RE: 3401 Calle Vigo NW
Grading and Drainage Plan
Engineer's Stamp Date: 03/27/23
Hydrology File: H12D003A1

**ADDENDUM 1
TECHNICAL DRAINAGE STUDY**

**3401 CALLE VIGO
LIMA RESIDENCE
H12D003A1**

**RE: ADDENDUM 1- TO THE TECHNICAL DRAINAGE STUDY FOR 11674 STARDUST DRIVE
LOT 51 (PW23-11151)**

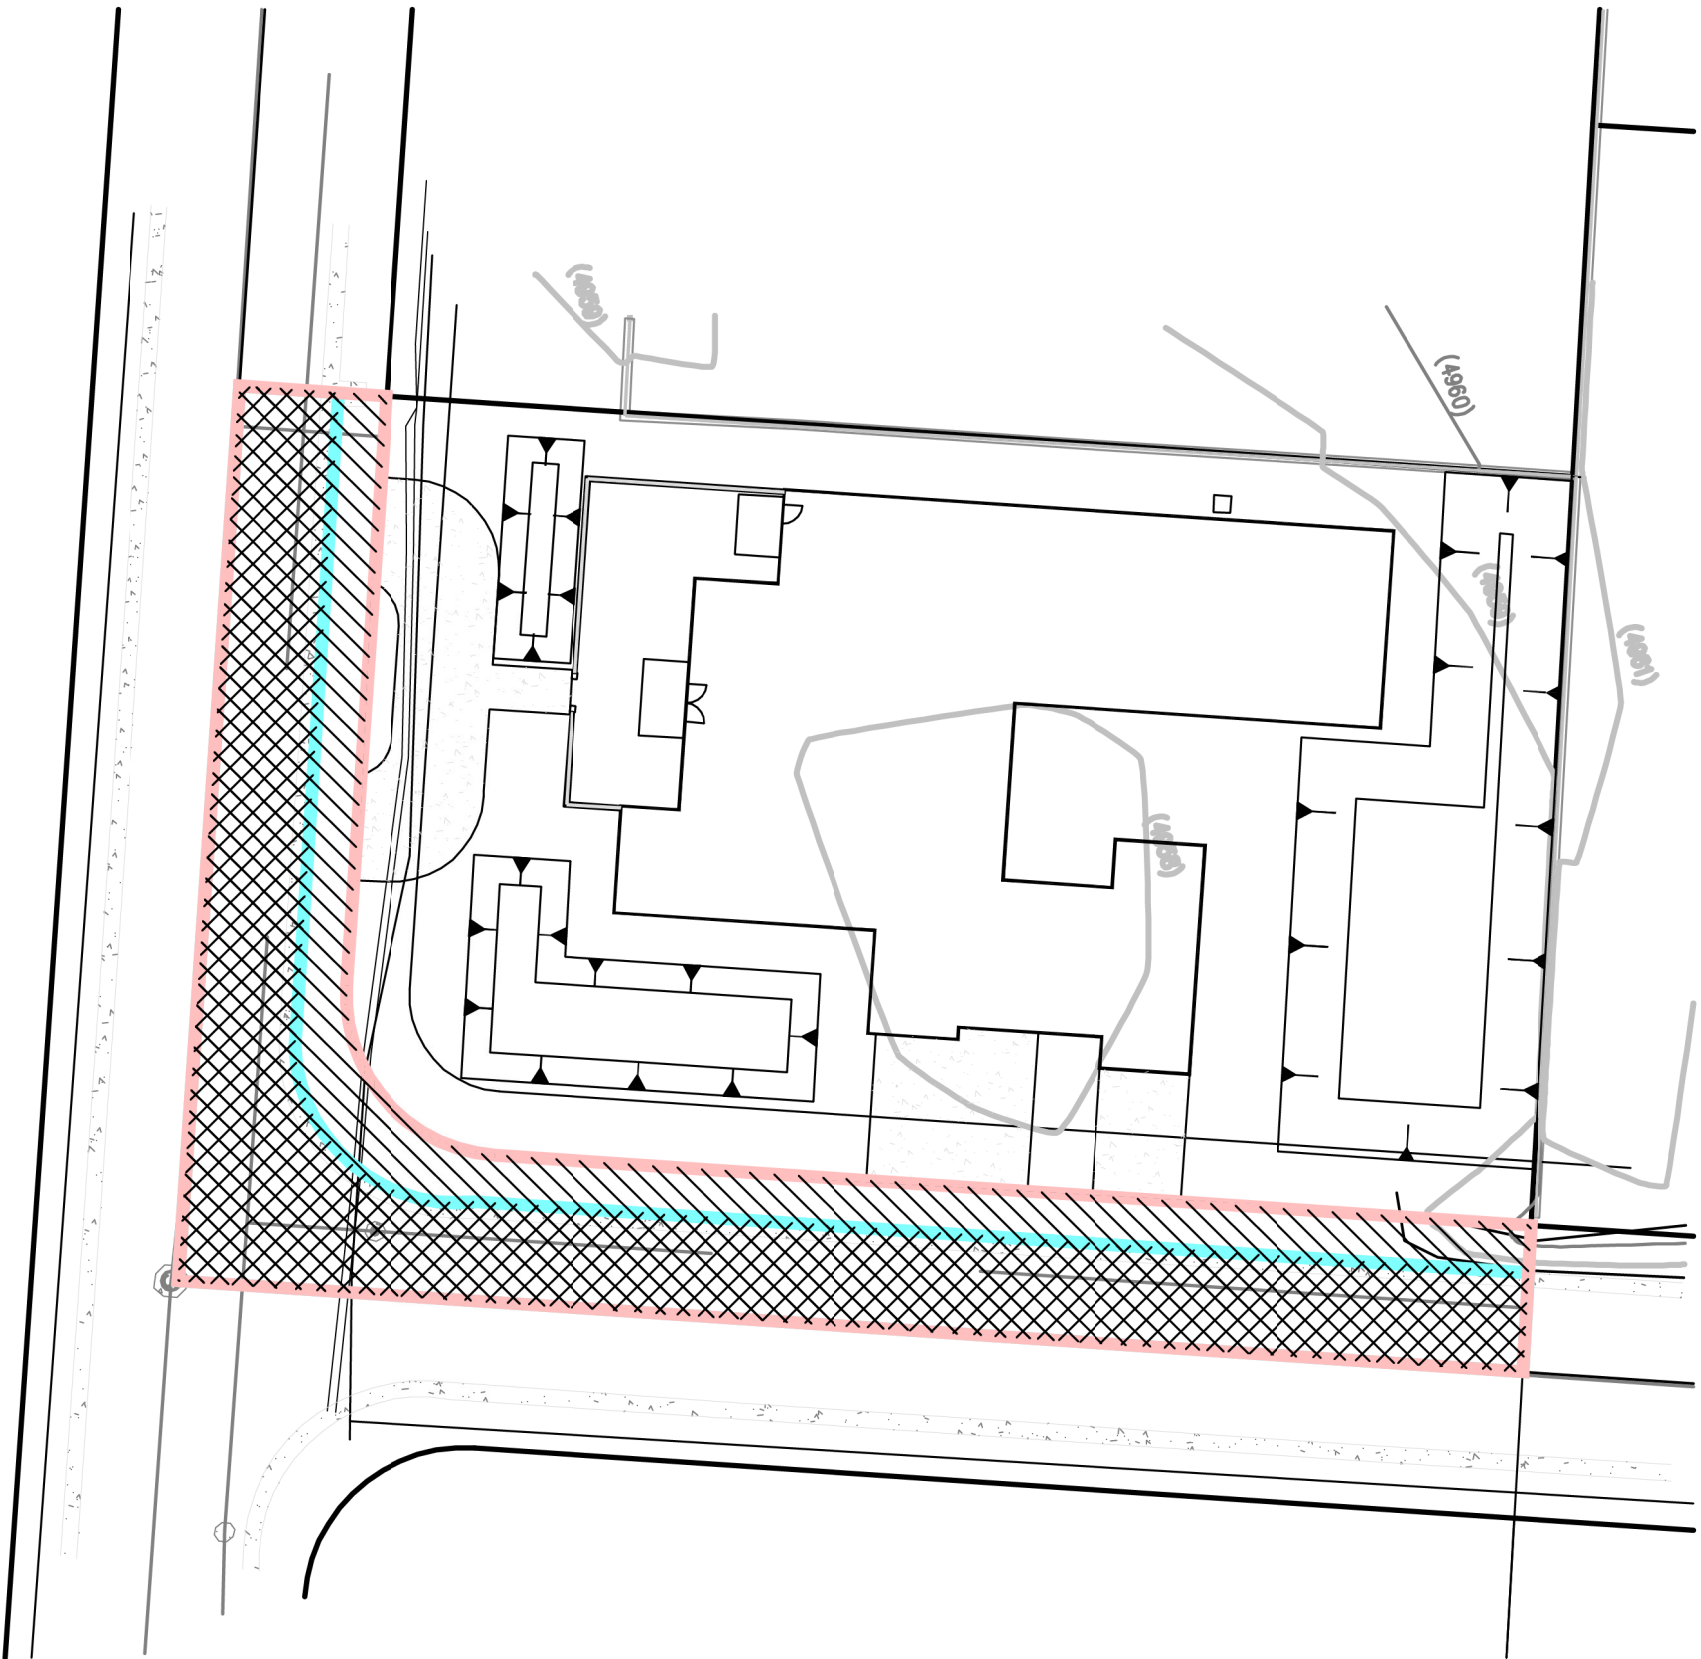
Comment 2.- According to the approved Master Grading Plan, this site has a maximum pad size of 5,596 SF and required retention pond volume of 0.279 AC-FT or 12,153.22 CF. This design will have to be revised to accommodate this requirement. The site flows outside the Building Lines drains to the street(s) and the flows inside the Building Lines drains to the rear retention pond.

Response The house pad for this project is ± 6663 SF. The increase in house pad impervious area has been updated to determine the required retention pond volume. The new volume using the current DPM is 4648 CF required.

3401 CALLE VIGO NW LIMA RESIDENCE
ROADWAY AREA EXHIBIT

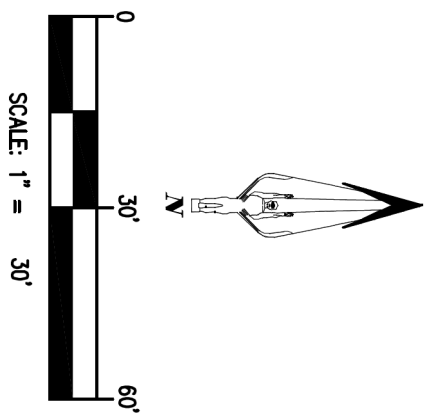
| Comment | <p>1.- Since this site is in the Valley region, please follow Article 6-5 Valley Drainage Criteria of the DPM. The following conditions must be applied to the site:</p> <ul style="list-style-type: none">a. The maximum percent impervious of the lot and the contributing area may not be greater than 45%b. Pad elevation shall be a minimum of one (1) foot above the 100 year 10-day stormwater surface elevation.c. The flow between the front yard and back yard cannot be obstructed. The stormwater must be allowed to equalize to the same level between the front yard and back yard.d. A permanent perimeter wall or barrier around the development is require to contain the 100-year 24-hour storm developed runoff |

| Response | <ul style="list-style-type: none">a. The proposed house pad will be 6634 SF which is approximately 1,000 SF larger than the pad of the previously approved Master Plan for the lot. The roadway area has been revised from the original to match the current day survey. The total impervious area is calculated using the house pad size (6663 SF) and the roadway area (5595 SF) which results in a total impervious area of 11998 SF. This area is less than the 45% max. The total impervious area for the lot would be less than 45%.b. The house FF elevation was determined using the water surface elevation from the previously approved Master Plan for Lot 15. The water surface elevation for Lot 15 is 4953.50'. This was used to determine the relative height difference between the WSL and the bottom of the pond. The difference is 1.7'. The minimum FF for the building is 4960.29' which is lower than the proposed FF.c. Two additional retention ponds have been added to the front of the building. The ponds are now connected with pipes that allow the stormwater to equalize.d. A wall is proposed around the site in order to protect the adjacent area from the storm developed runoff. |
